OLD STYLE SEAS. WELL WITH NO ANGLE ON MTG. BKT OF HANDY BOX BUT WITH SEAS. WELL SLIDES.

SEASONING WELL HEATER RETAINER PLATE

OLD STYLE 104 SEASONING WELL  
WITHOUT HANDY BOX AT REAR  
OF SEASONING WELL

A-127-9012

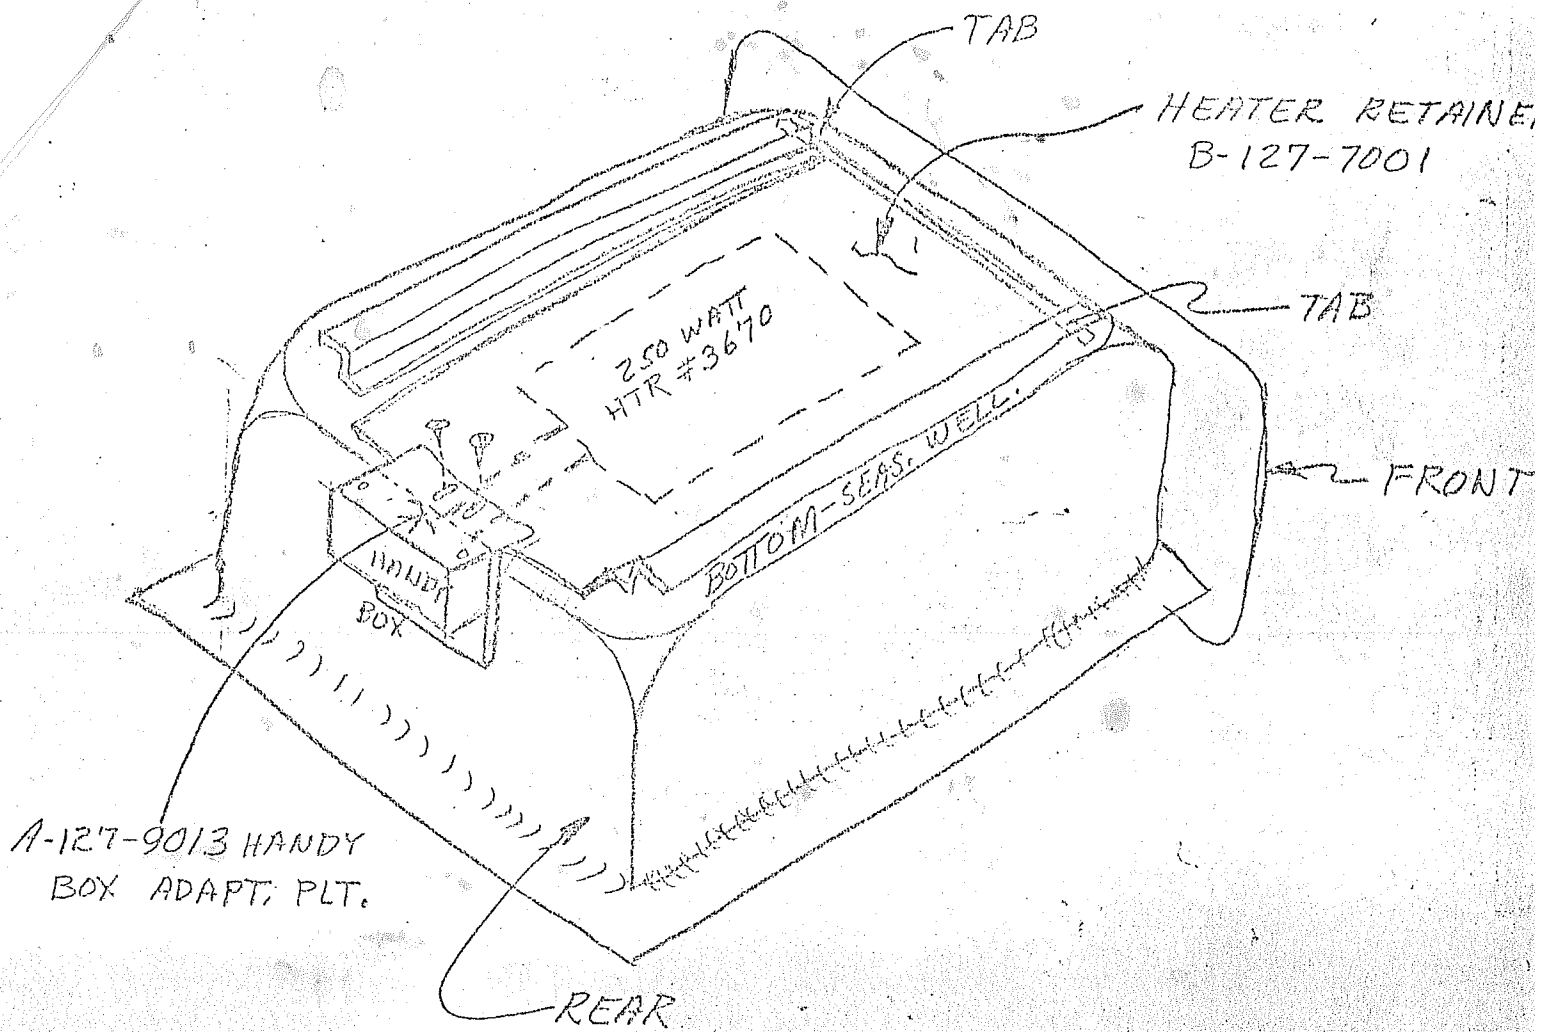
OLD STYLE SEAS. WELL WITH NO ANGLE  
ON MTG. BKT OF HANDY BOX BUT WITH  
SEAS. WELL SLIDES.

REMOVE OLD HEATER AND REPLACE WITH #3670 HTR. WIRE  
HEATER IN SAME WAY THE OLD UNIT WAS WIRED BUT DO  
NOT REPLACE OLD HANDY BOX COVER. PLACE HEATER RETAINER  
AS SHOWN WITH "EARS" OR "TAB" UNDER SEAS. WELL RUNNERS AND  
PUSH RETAINER TO REAR, SECURING TABS UNDER SEAS. WELL  
RUNNERS AT FRONT END. PLACE NEW HANDY BOX COVER AS SHOWN  
AND SECURE TO HANDY BOX WITH OLD SCREWS. WITH (2) TWO  
#6 SHEET METAL SCREWS SUPPLIED, SECURE NEW HANDY BOX  
COVER TO HEATER RETAINER PLATE AS SHOWN THUS SECURING  
HEATER INTO PLACE.
